CITY OF HORSESHOE BAY

CITY OF HORSESHOE BAY
PLANNING & ZONING COMMISSION
APRIL 5, 2016

RE: Consider, discuss and take action regarding a recommendation to City Council regarding the preliminary plat and final plat of Hidden Coves, a 22 lot subdivision with 19 garden home lots, 1 R-4 Multi-family lot (for future development) and 2 LA Lake Area lots to be zoned Mixed Use GH Garden Home R-4 Multi-Family LA Lake Area PD Planned Development - MU-GH-R4-LA PD (10.43 acre area on the east side of Faultline Dr., across from Nichola Gay, north and south of Diagonal Dr, and north of Lost Echo)

Staff Review Comments

PRELIMINARY PLAT OF
HIDDEN COVES, A PLANNED DEVELOPMENT
HORSESHOE BAY WEST
PLAT NO. W36.3
10.43 ACRES
OUT OF THE ROBERT BRATTON SURVEY NO. 1, ABSTRACT NO. 37
CITY OF HORSESHOE BAY
LLANO COUNTY, TEXAS
SHEET 2 OF 10

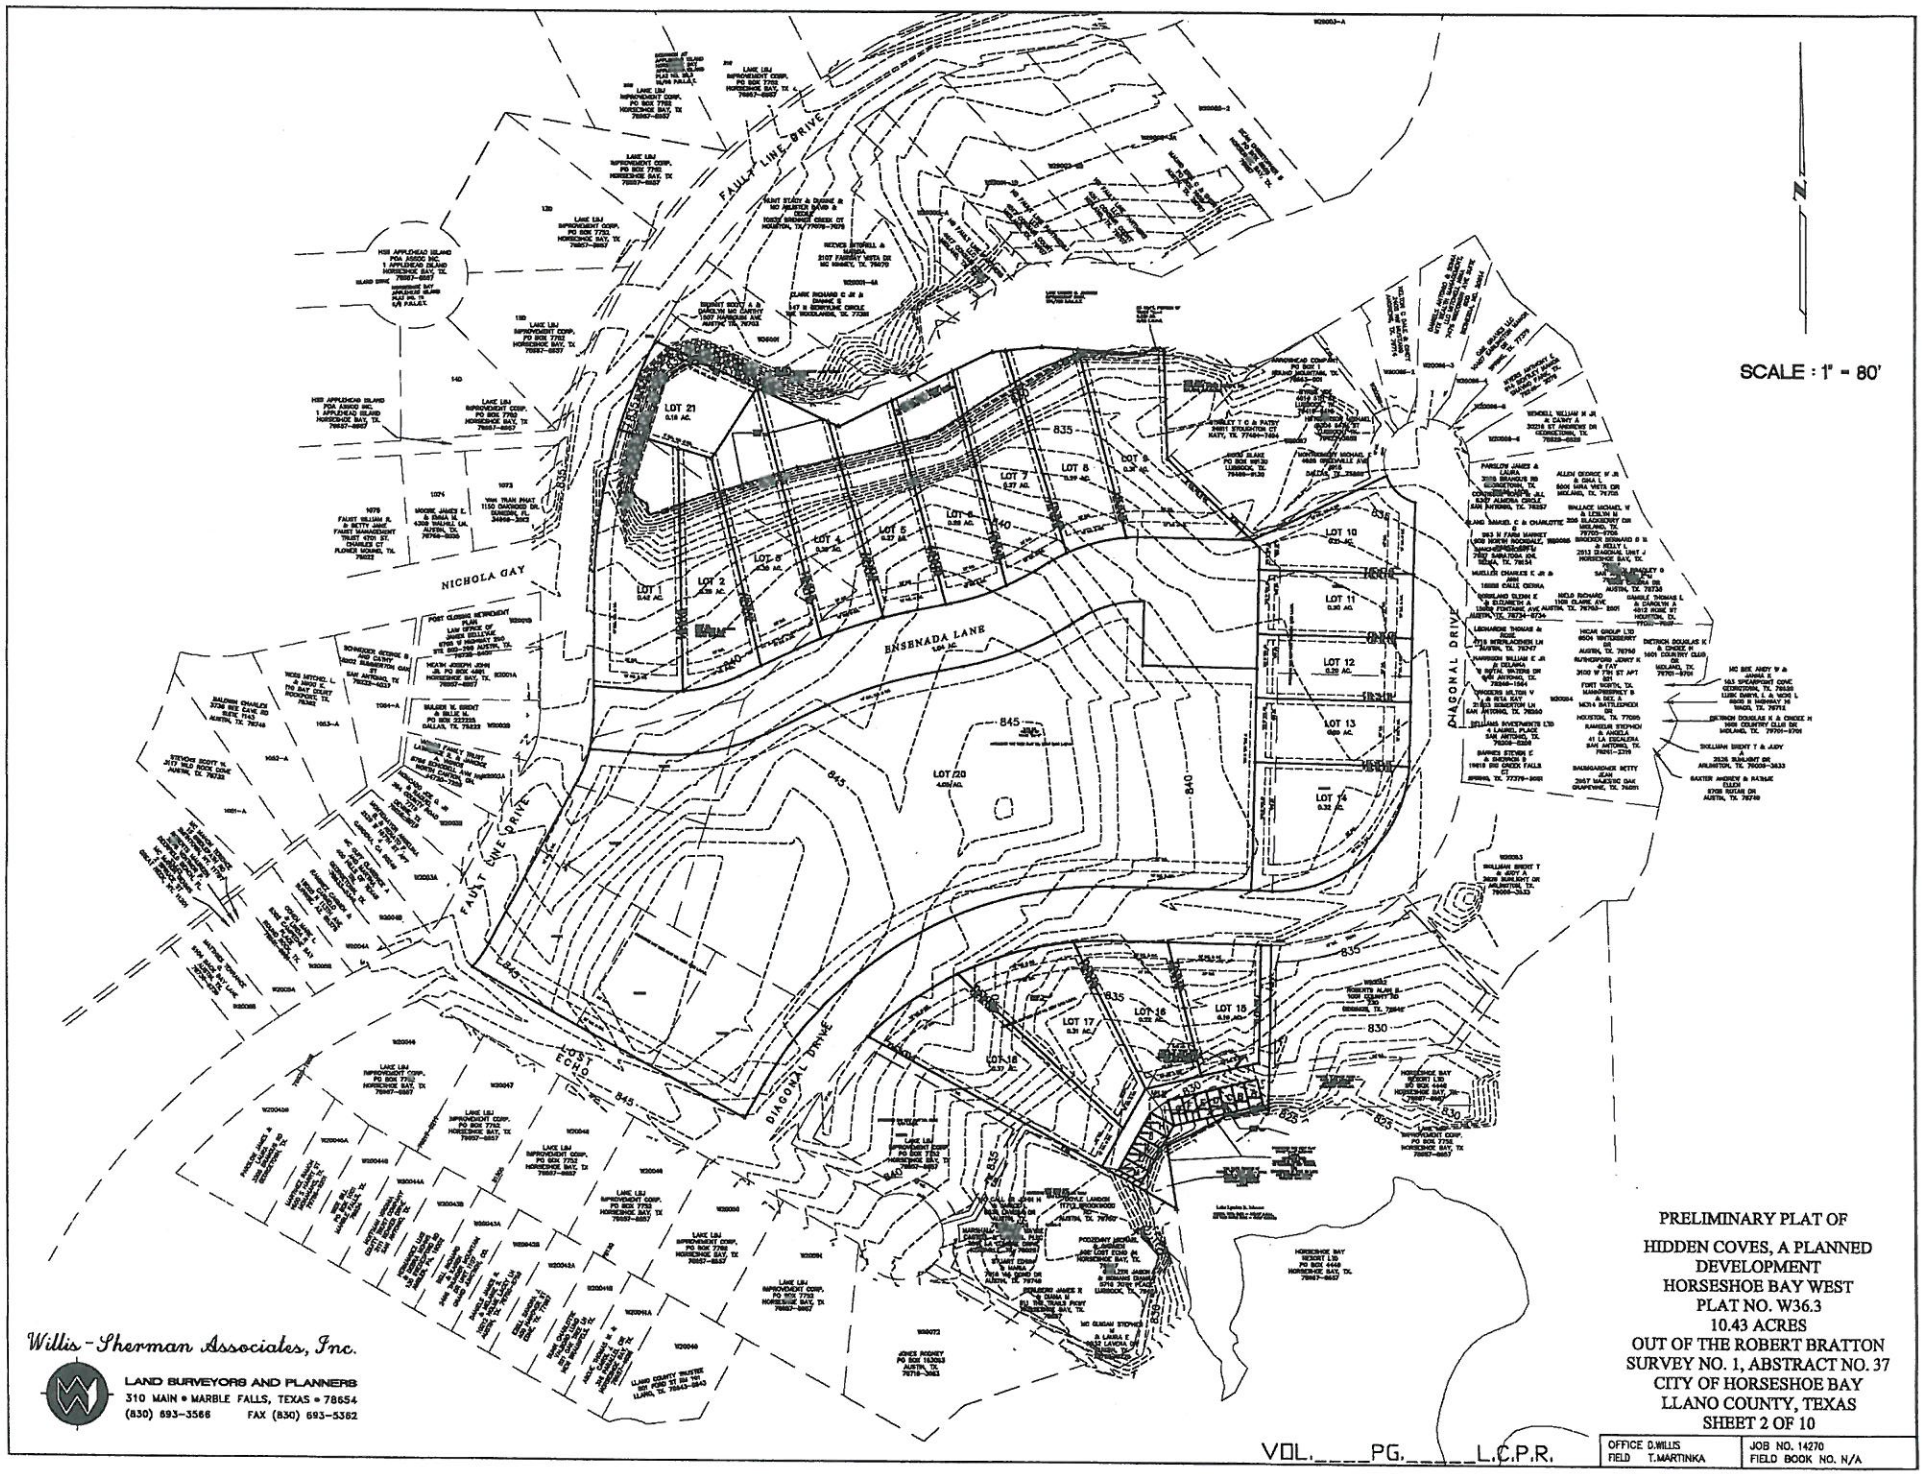
8. **Show accurate reference ties to courses and distances of at least 2 recognized land corners on Sheet 2 of 10.**
9. **Finished floor elevations of 2 feet above the 100 year flood plain elevation shall be shown on the plat, for all waterfront lots and all lots in the 100 year floodplain.**

10. **Add a location and description of all monuments, which shall be placed at each corner of the boundary survey of the subdivision on Sheet 2 of 10.**
